RE: The Glade - 200 N 7th Ave - Xcel Final Site Plan Review

Xcel Energy – Review Comments – Plat and/or Site Plan

Reviewing: The Glades Development 200 N 7th St – Civils & Architectural for Electric Distribution

TO: KRIS VALDEZ; PRINCIPAL PLANNER, SETH FRANCIS
FROM: CHRISTOPHER MCGINNIS, PUBLIC WORKS DIRECTOR/TOWN ENGINEER
RE: MAJ 24-0005 ENGINEERING/PUBLIC WORKS REVIEW
DATE: JULY 11TH, 2025

FINAL PLAN
GRADING AND DRAINAGE PLAN

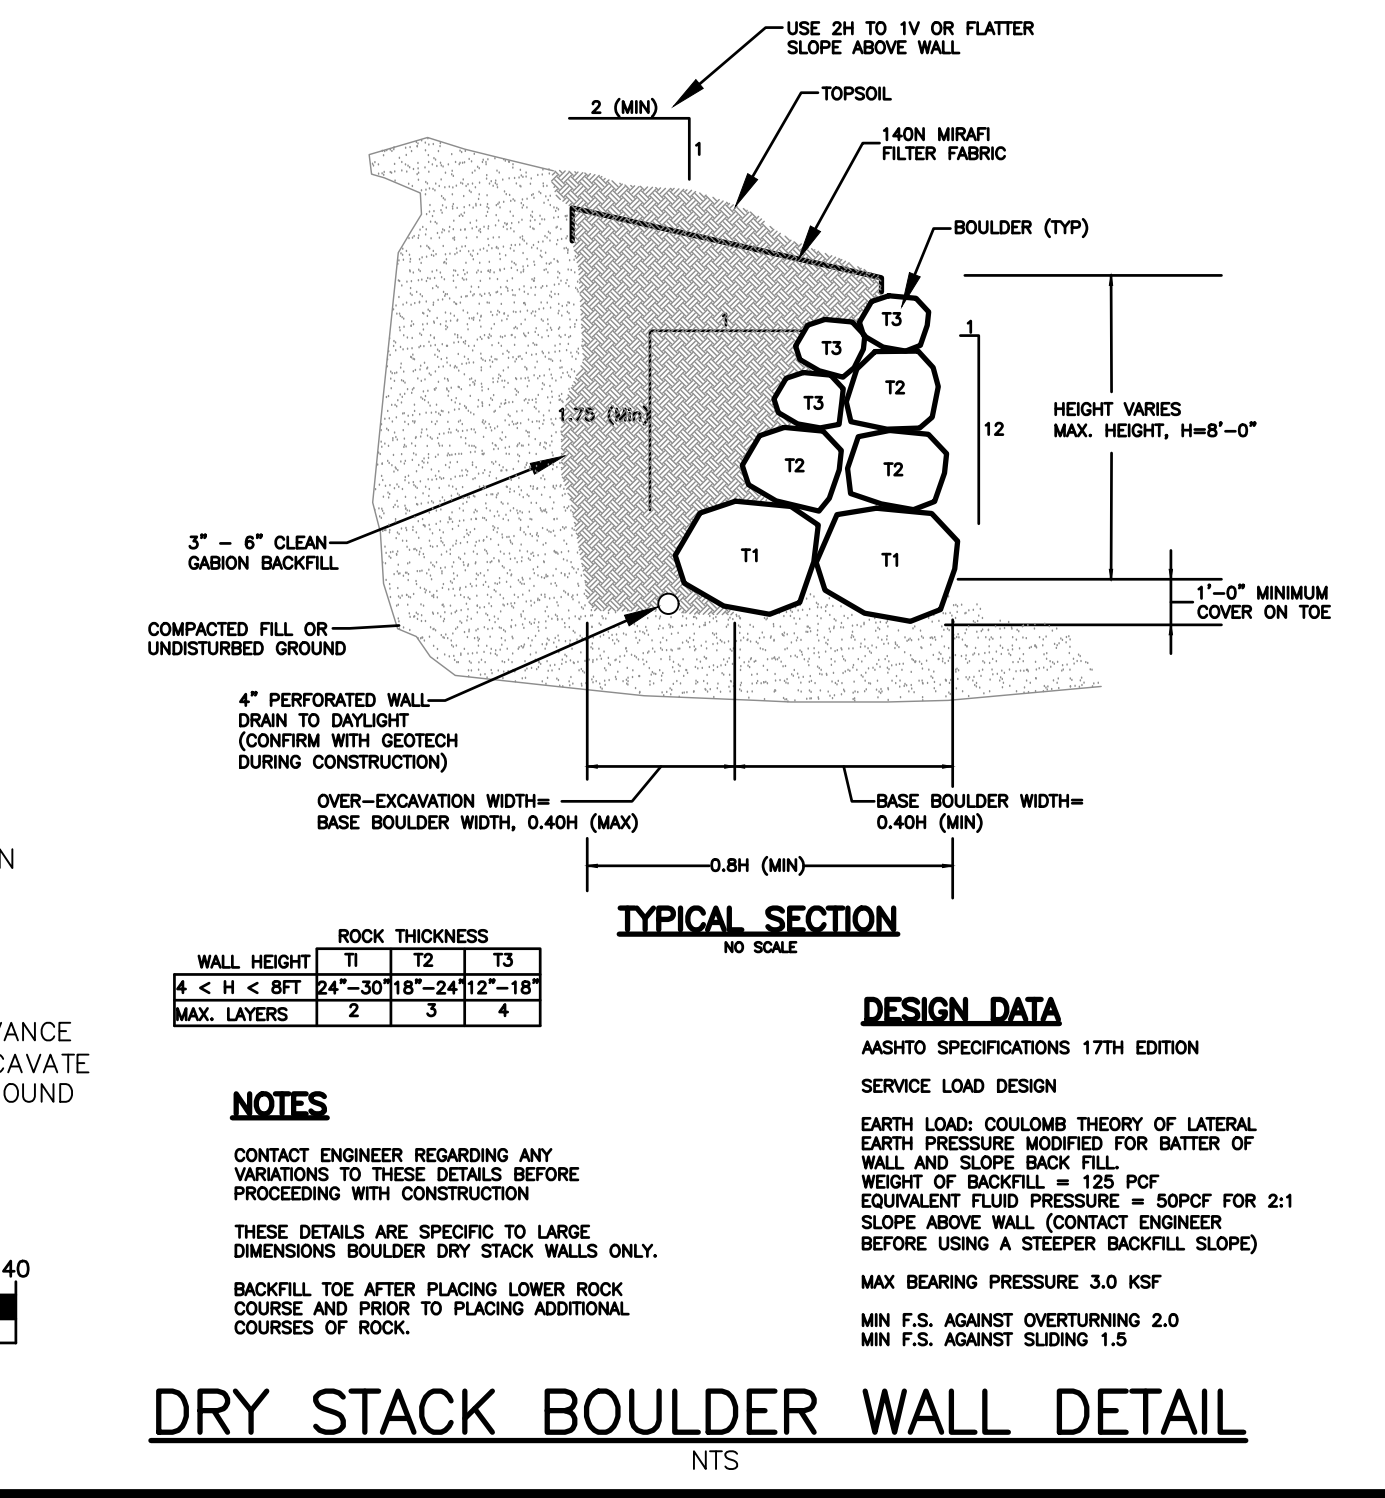
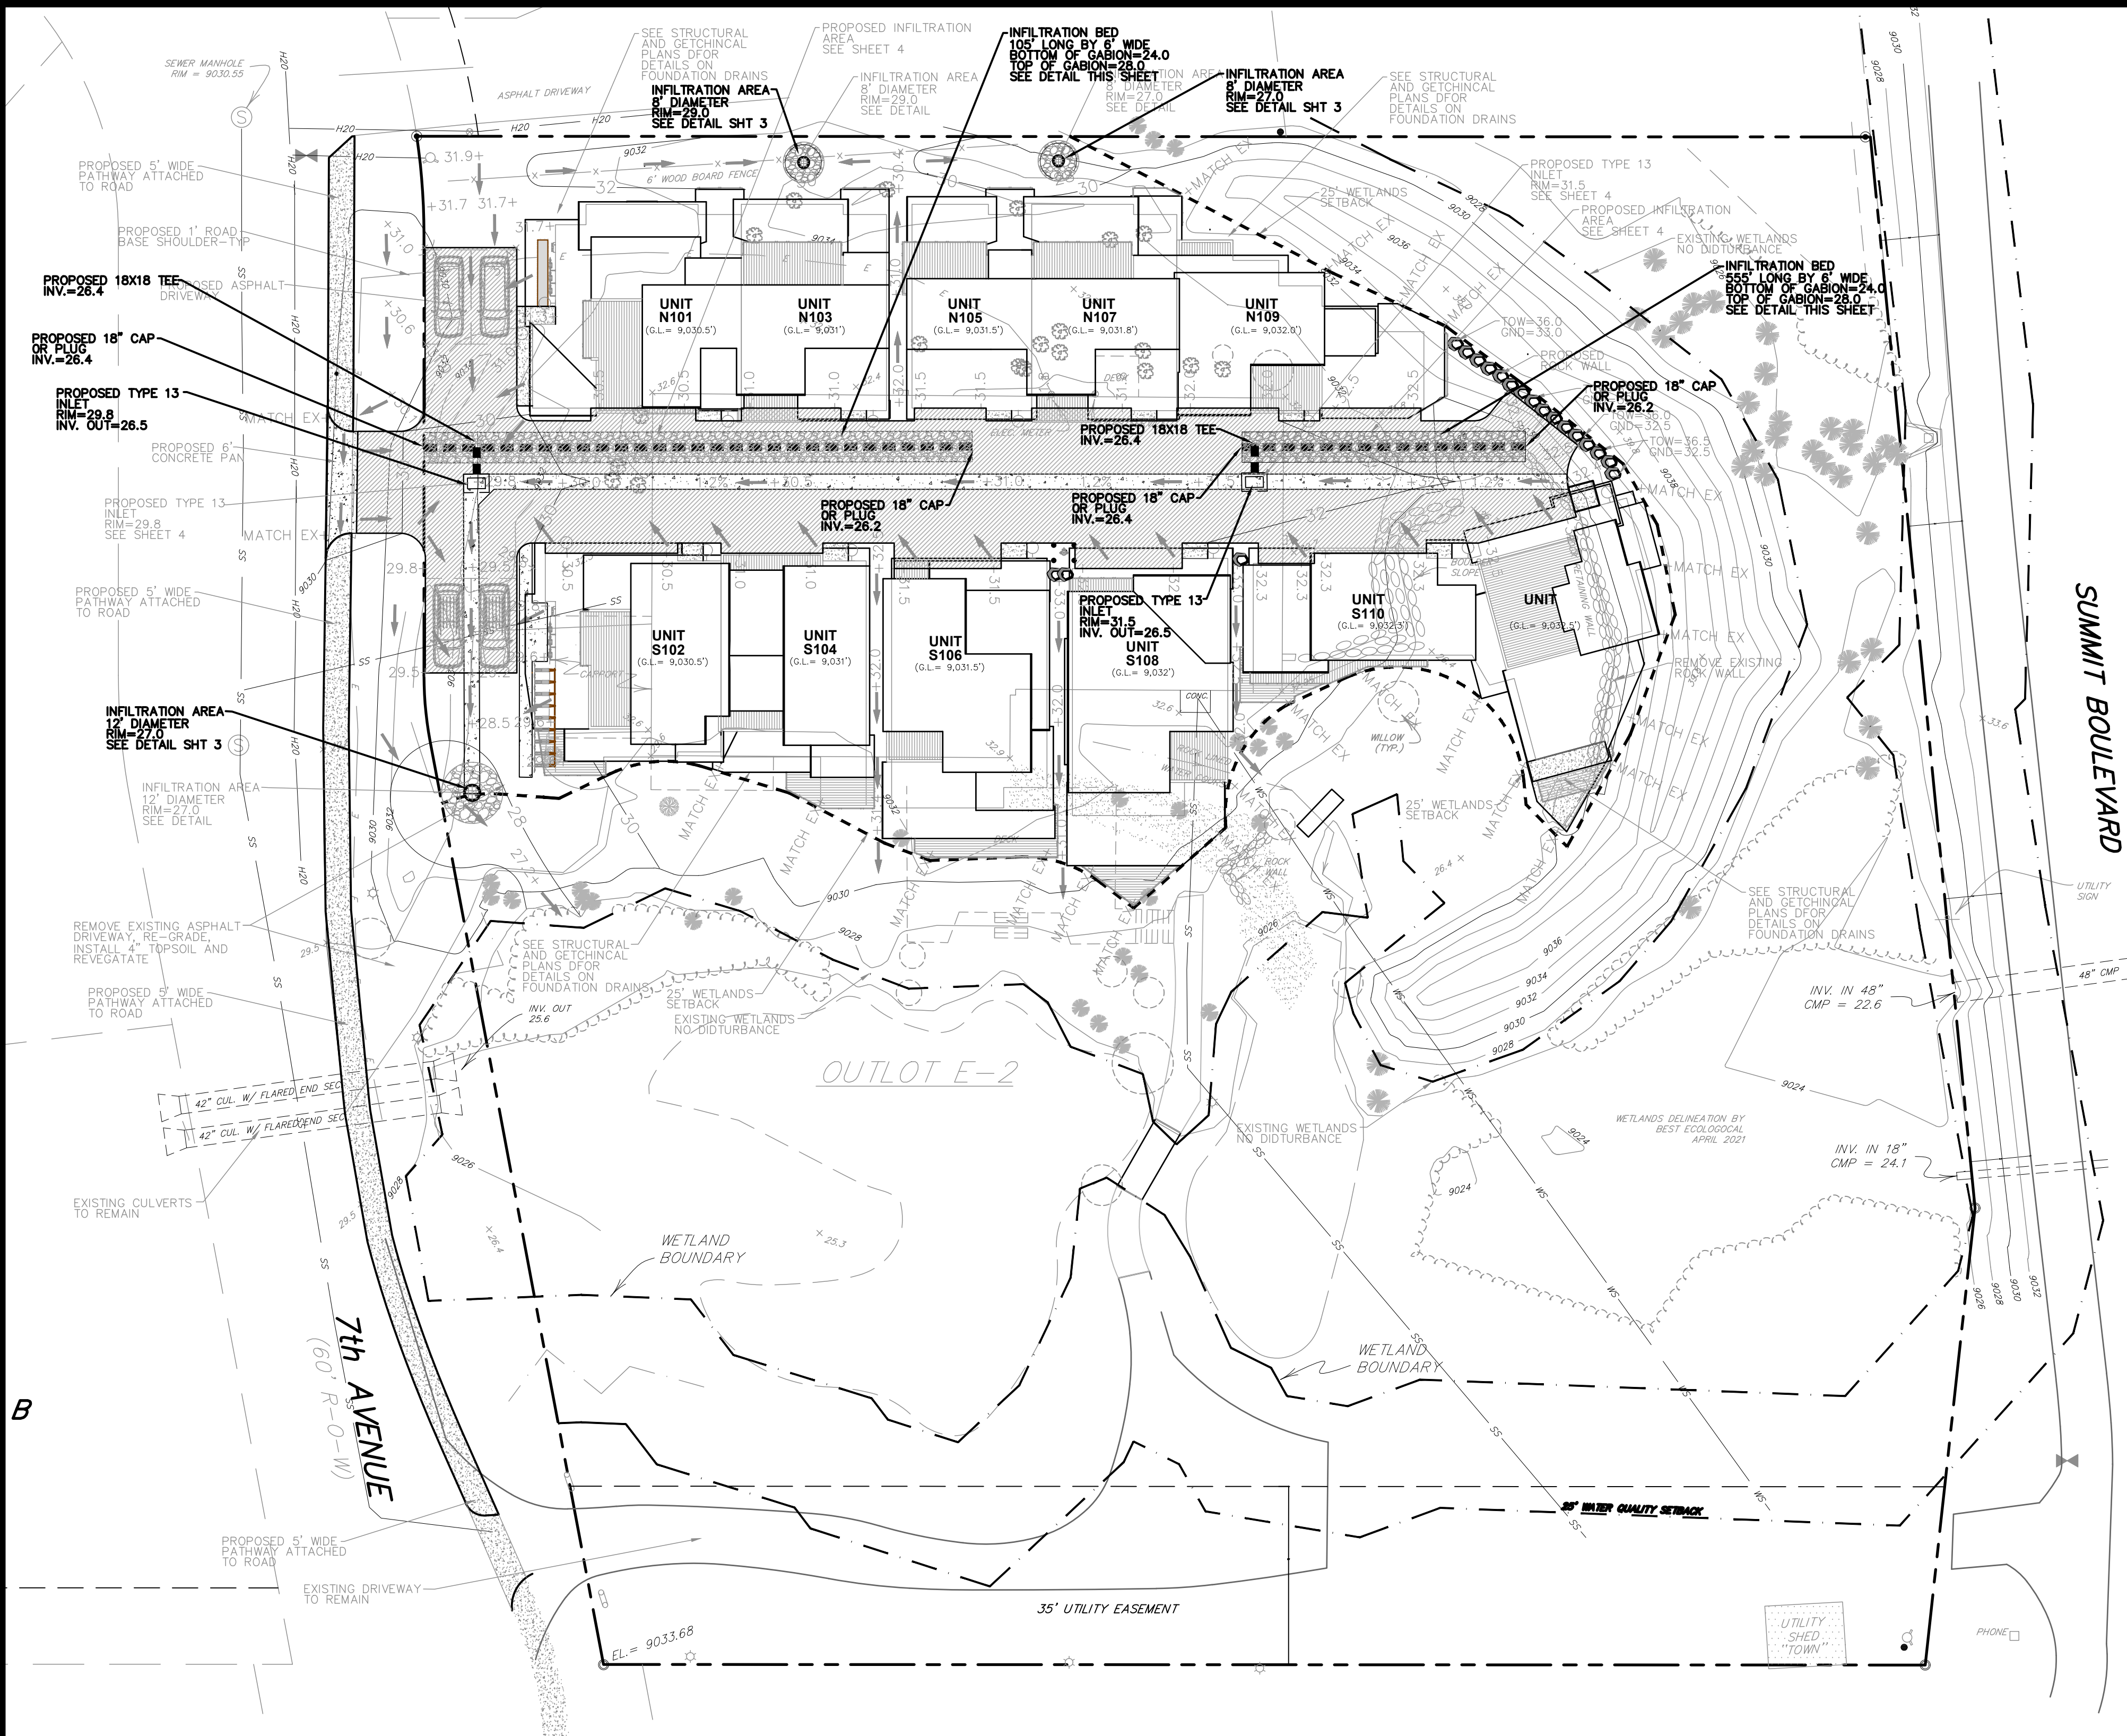
- Right of Way Permit required for utility connections and new sidewalk.
- Sidewalk shall include Type 1B curb, driveway cuts per CDOT detail M-608-1, boulder walls where needed to avoid wetland disturbance, and inlets/drains where needed for drainage. The south limits of sidewalk also need to be detailed. Additional detail for sidewalk and roadway required at building permit.

- Depth of infiltration bed to be detailed on building permit plans. Depending on depth, groundwater could be an issue.
- Soils report recommends foundation drains.

- Water services shall be perpendicular.
- Revise landscaping plan. No trees allowed within 5' of proposed sidewalk for snow storage.
- Traffic Study was reviewed and approved. Study indicates minimal traffic increase and no mitigation required per Town code.
